DCUSA DCP 139 Consultation Responses – Collated Comments

Further Figure 8 on page 558 (reproduced below for convenience) sets out an example network to illustrate the distinction between level 1, 2 and 3 network groups. Importantly, it shows that the GSP busbar (on the distribution side) is part of the level 1 network group.

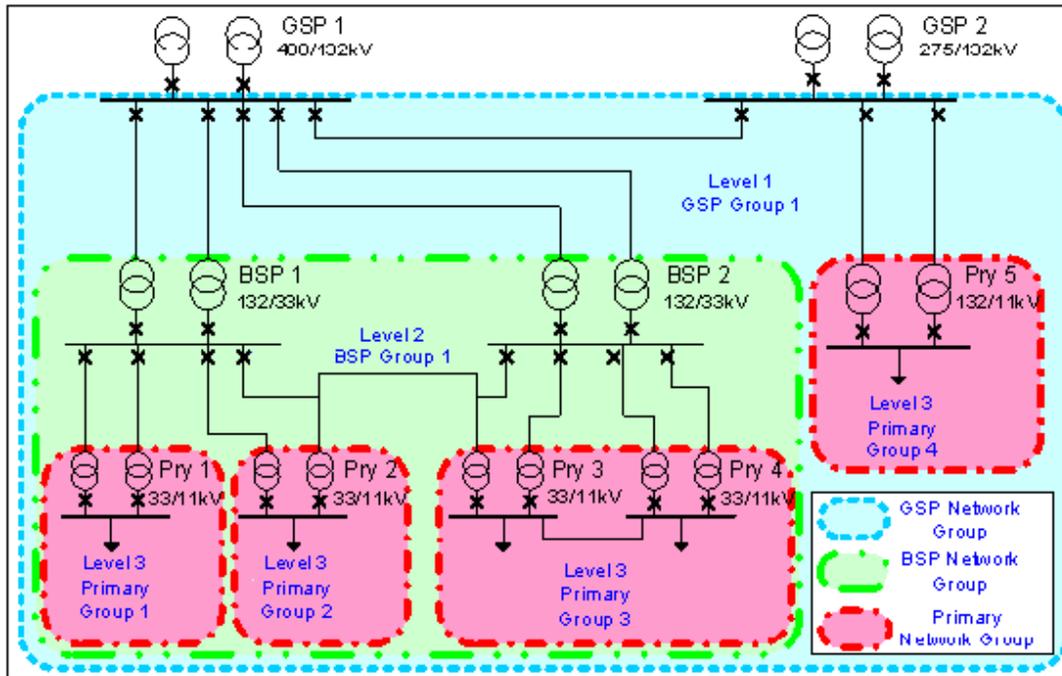
The only interpretation of this diagram is that a customer where the point of common coupling is at the GSP busbar is in a level 1 network group. Consequently, the methodology requires that the FCP charges applicable to that network group must apply to that customer.
